Project Name: Site Plan Amendment No. 81982069A, Silver Spring Center

Completed: 2.5.16

Summary

Figure 2: Proposed Site Plan

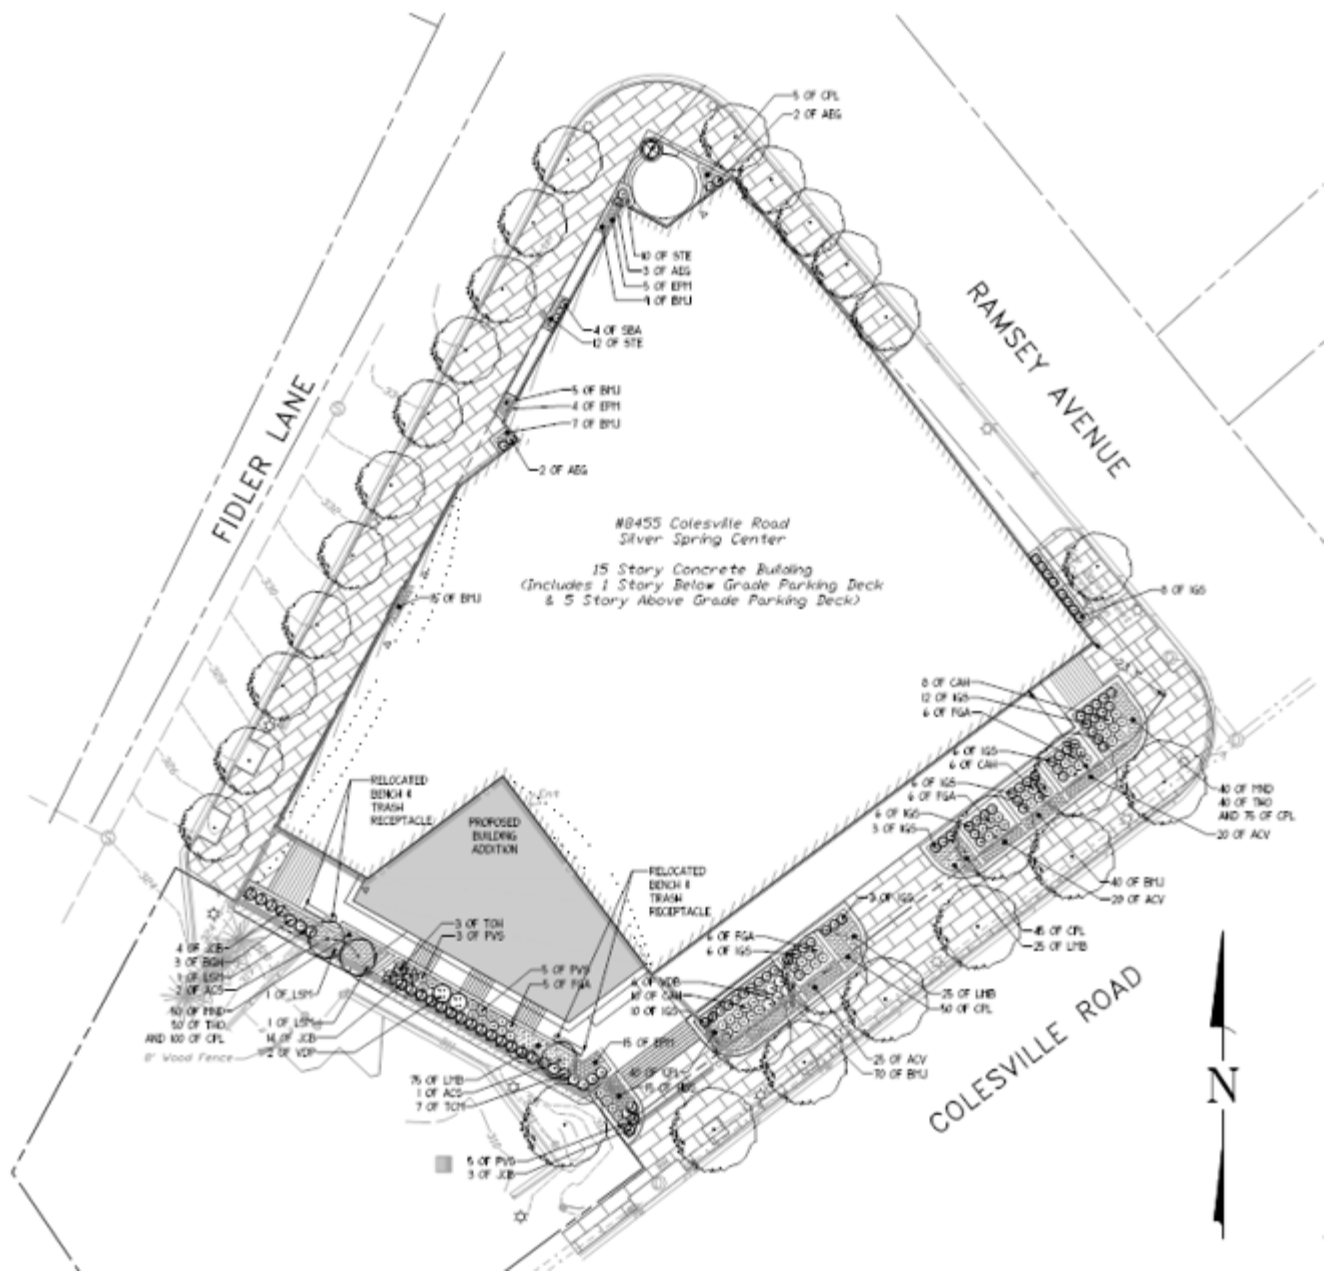
The building addition displaces about a third of the 10,894 square feet of public use space approved with the original development, a reduction of 3,894 square feet. The original approval required 30 percent of the net lot area as public use space, while the amendment proposes 22 percent. The public use space is being reduced in part to improve safety and security along the southern through-block pedestrian connection.

Additionally, a public art component, which was approved in 1982 for the northern corner of the site at the intersection of Ramsey Avenue and Fidler Lane but does not seem to have been installed, will be installed along the southern edge of the site as described above (shown in Figure 3).

- a. The Applicant must provide a minimum of 7,000 square feet of public use space (22% of net lot area) on-site.
- b. The Applicant must construct the streetscape improvements along the Property's street frontage, consistent with the Silver Spring CBD Streetscape Standards.

The Applicant must provide for and install the public art concept designed and fabricated by artist Alan Binstock as presented to the Planning Board's Art Review Panel on July 8, 2015, and illustrated in the Certified Site Plan. Any significant changes to the concept must be presented to the Art Review Panel and approved by M-NCPPC Staff before Certified Site Plan Approval. Significant changes to the concept may require a Site Plan Amendment.
